ADDENDUM No. 1

April 12, 2024

**Southfield Fire Stations #4 & #5
PAVING IMPROVEMENTS
0153-23-0180**

This Addendum contains 41 pages.

C-120

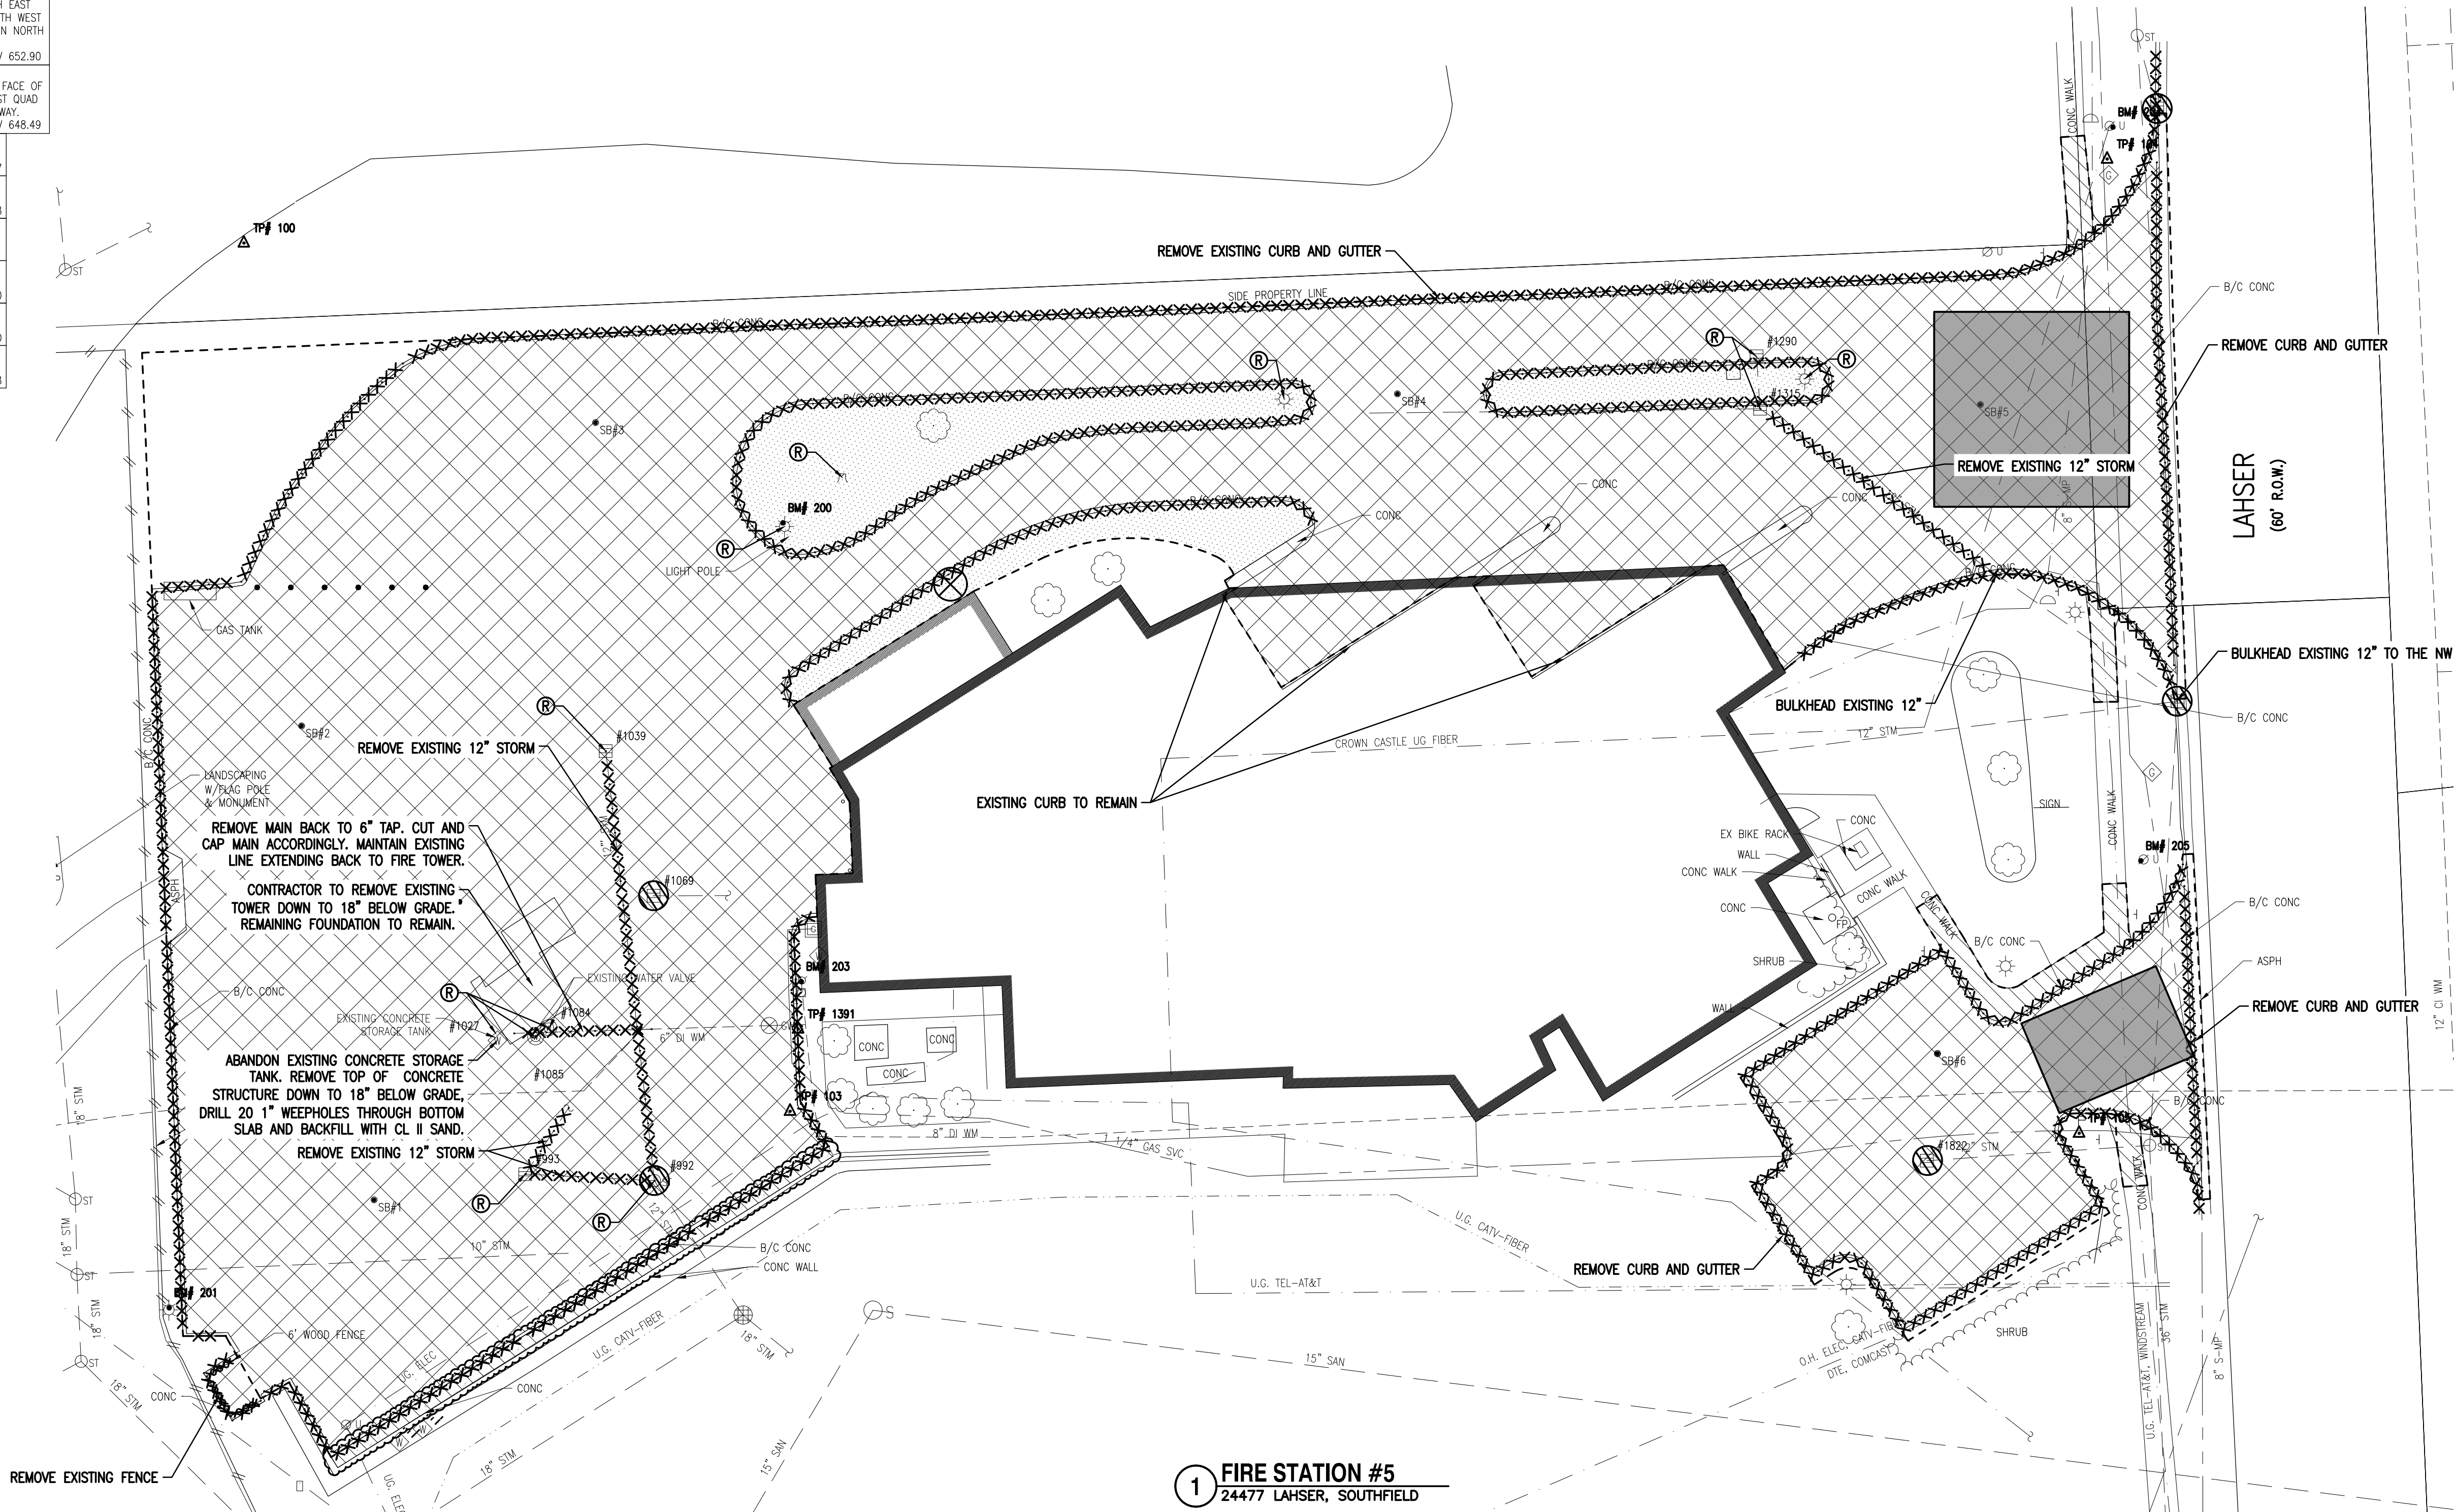
1. Replace the cover sheet the revised sheet attached to this addendum.
2. Replace plan sheet C-120 with the revised plan sheet attached to this addendum.

- a. Updated to show sidewalk removal at the southwest portion of the main parking lot near the existing retaining wall.
3. Replace plan sheet C-130 with the revised plan sheet attached to this addendum.

C-130

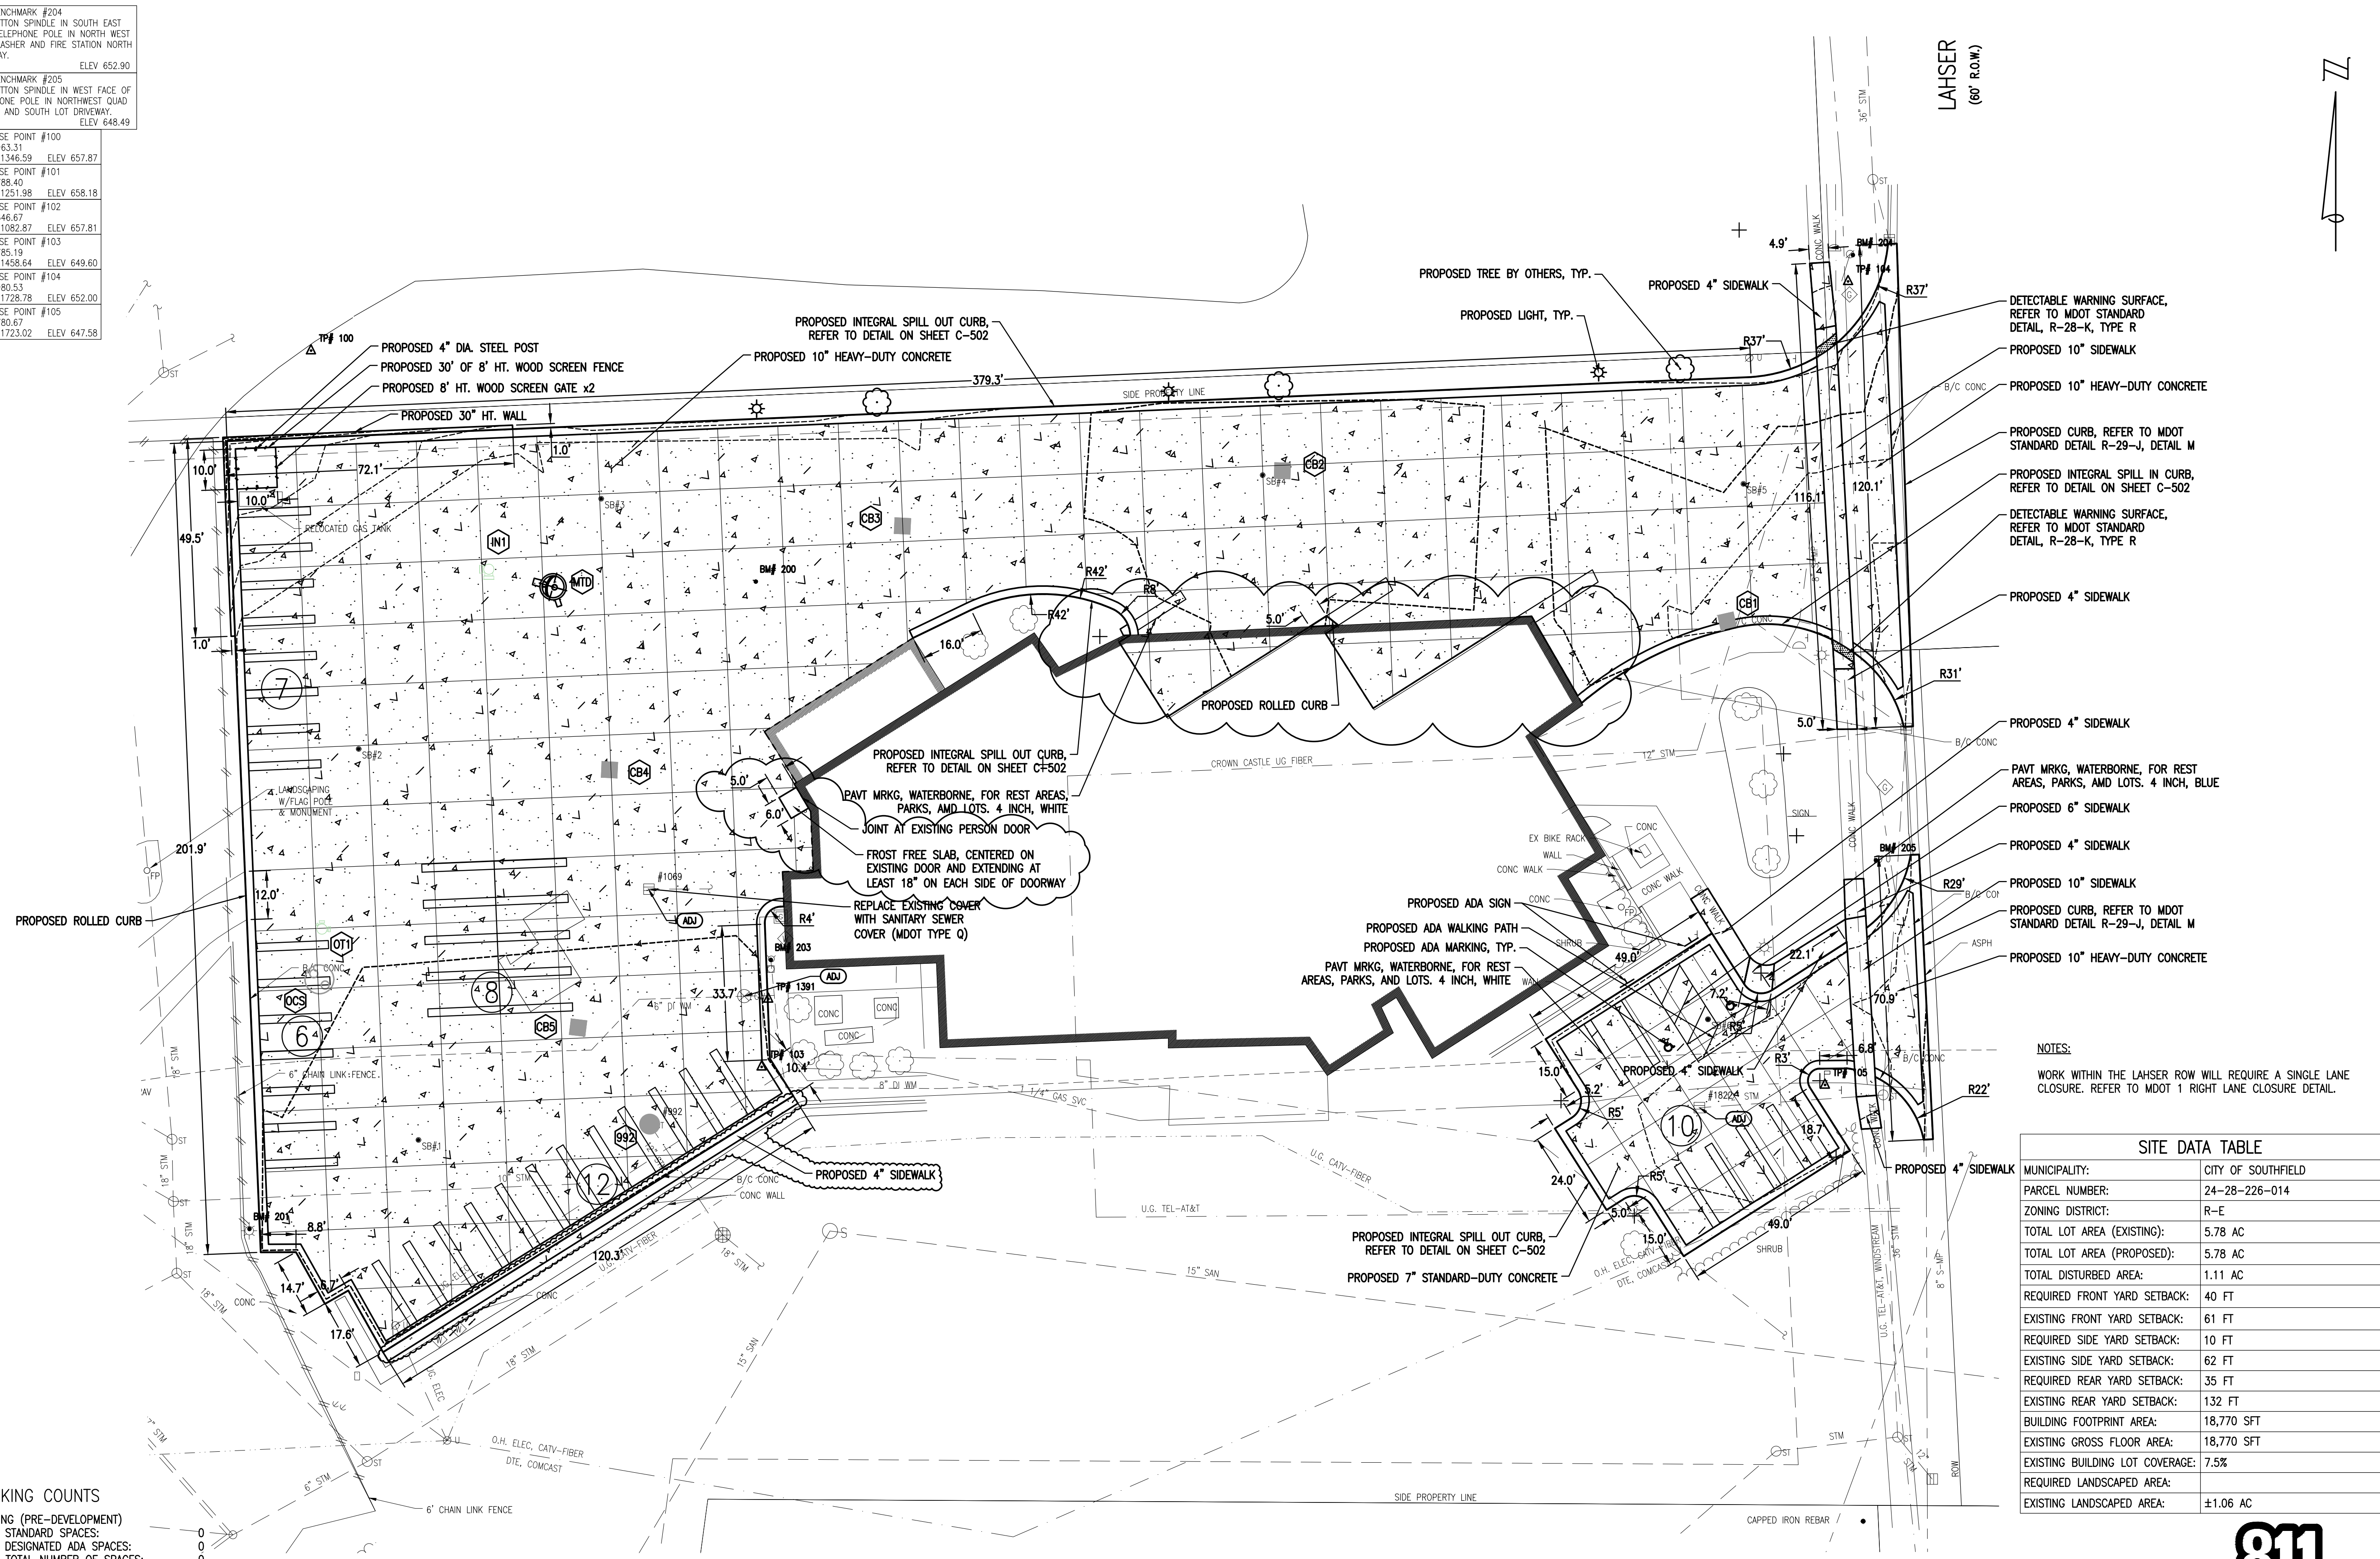
- a. Updated to show proposed 4" sidewalk at the southwest portion of the main parking lot near the existing retaining wall.
 - b. Clarified the location of the 5'x6' frost-free slab near the person door on the west side of the building.

- c. Revised proposed rolled curb length to 5 linear feet.
 - d. Clarified that frost-free slabs will not be needed at the vehicle entrances to the building.

C-140

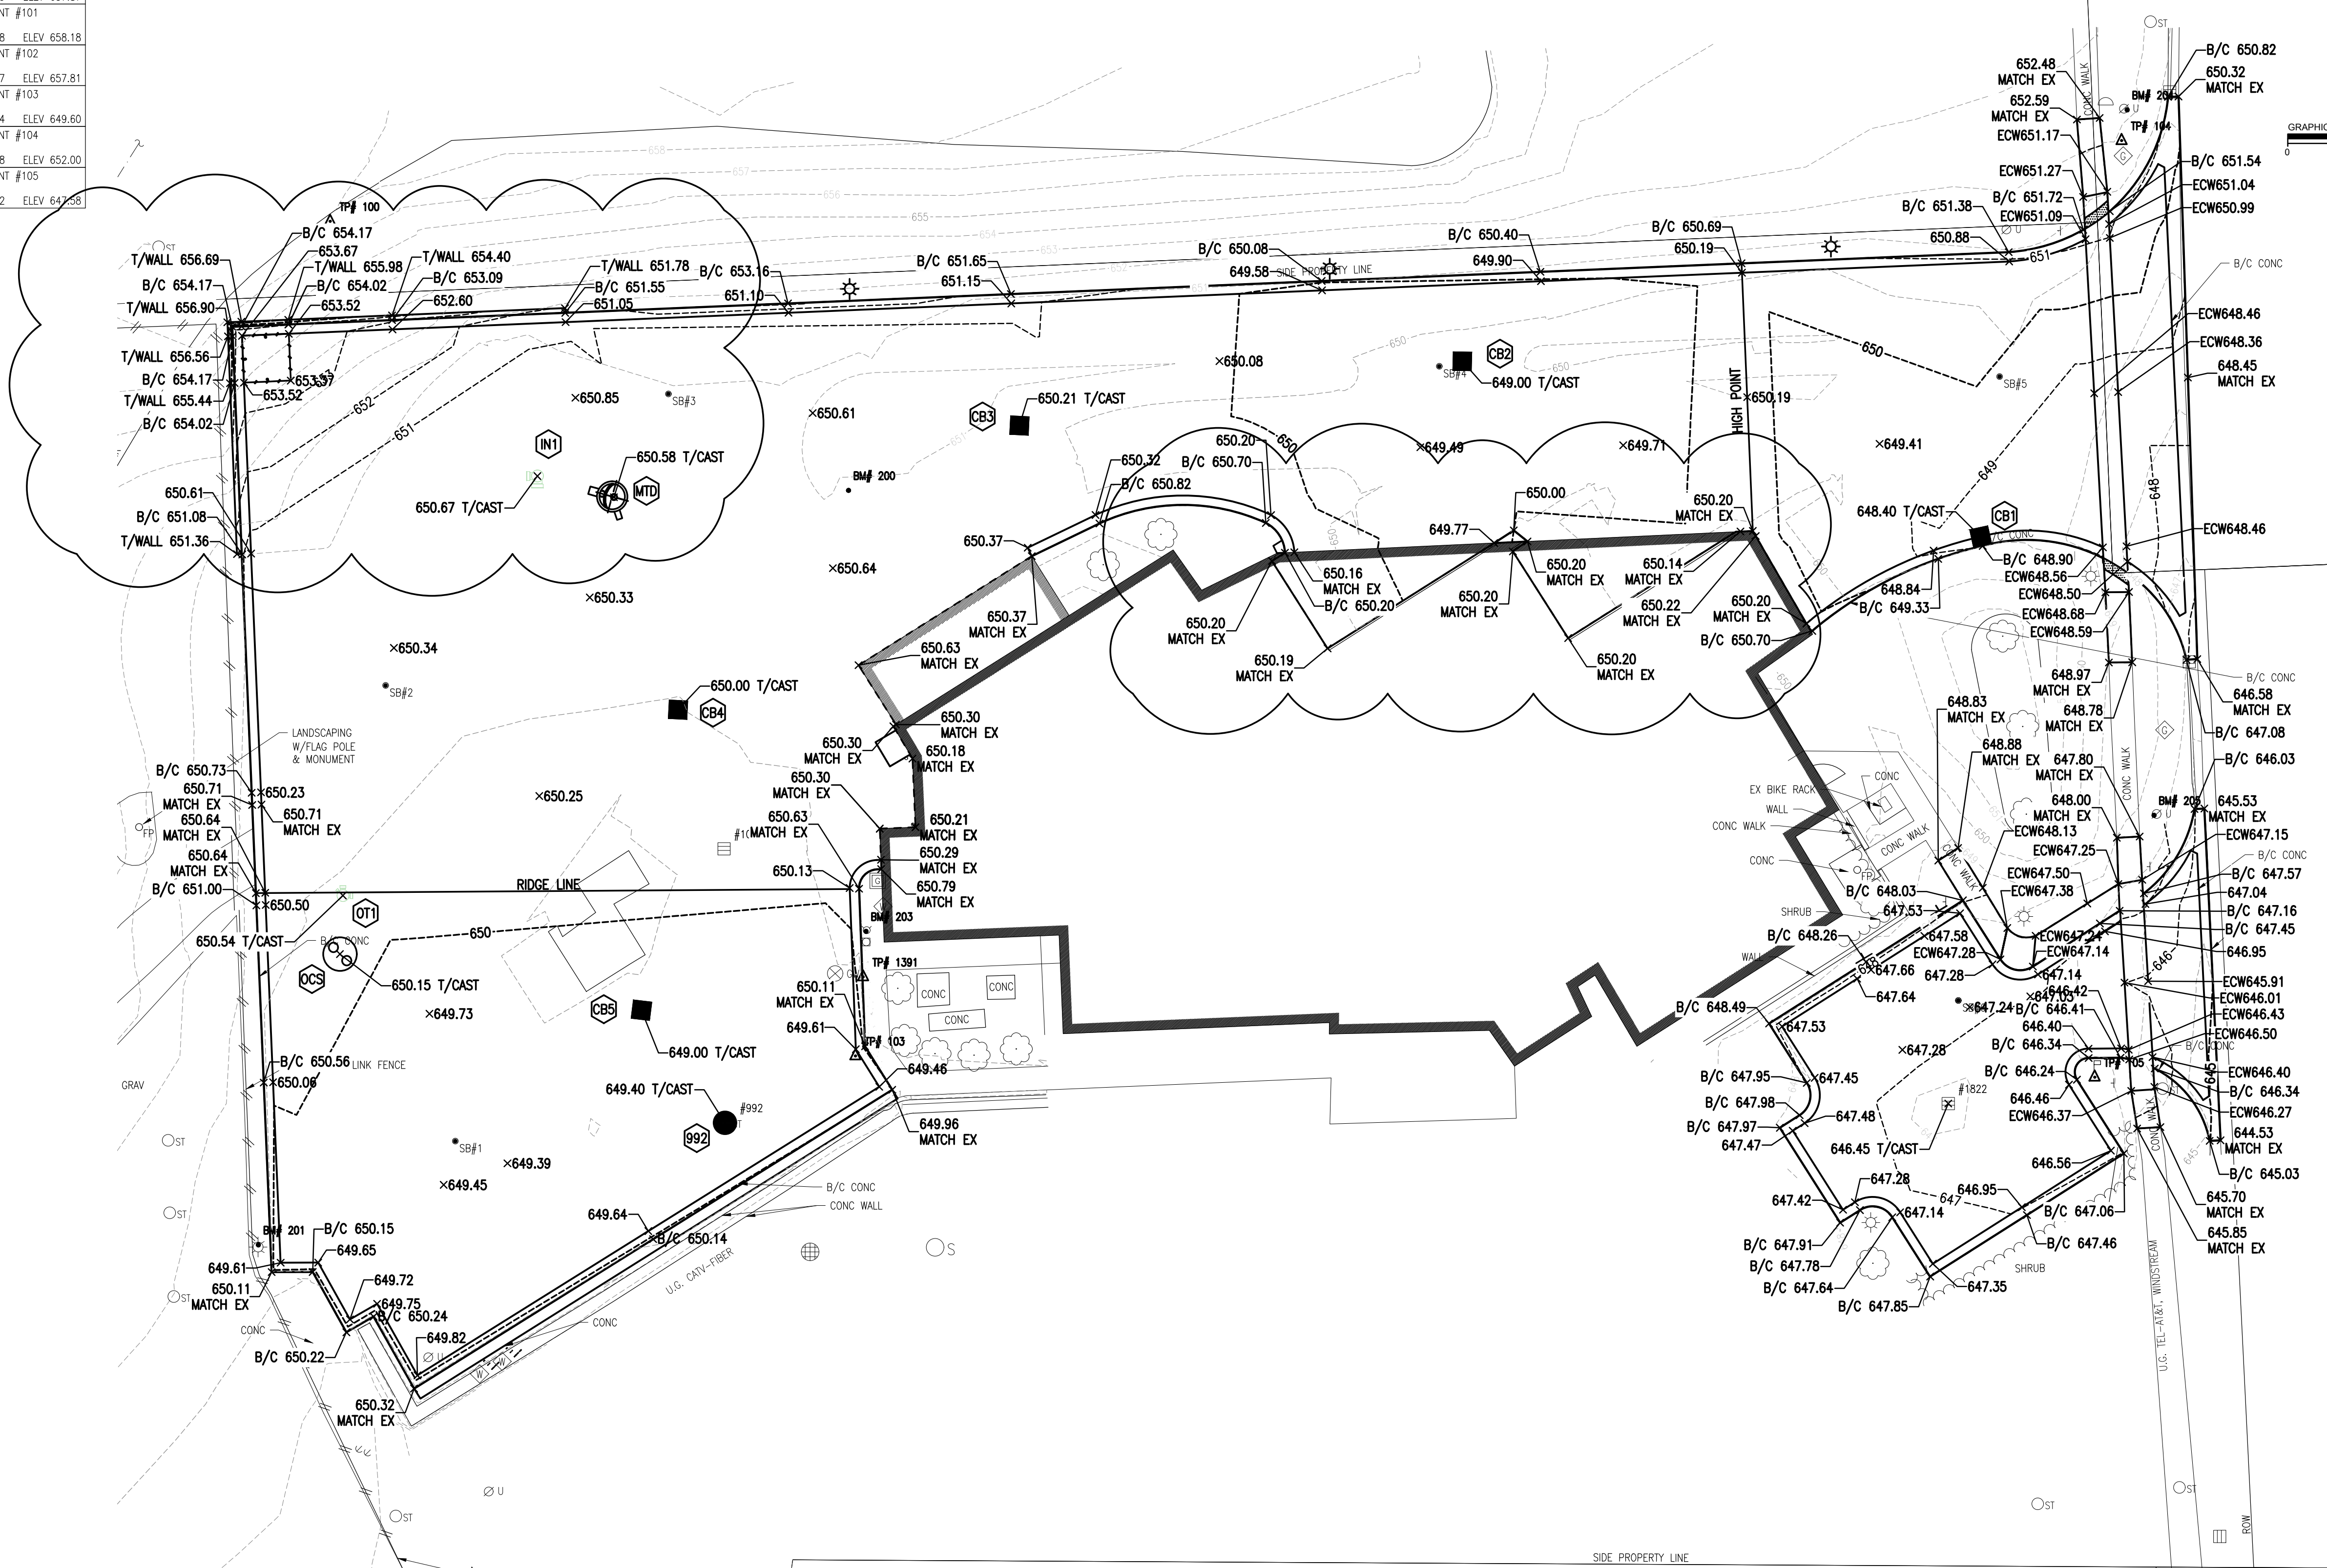
4. Replace plan sheet C-140 with the revised plan sheet attached to this addendum.
 - a. Revised proposed grading to the retaining wall at the northwestern corner of the site.

- b. Revised proposed grading to the bays on the north side of the building.
5. Replace plan sheet C-150 with the revised plan sheet attached to this addendum.
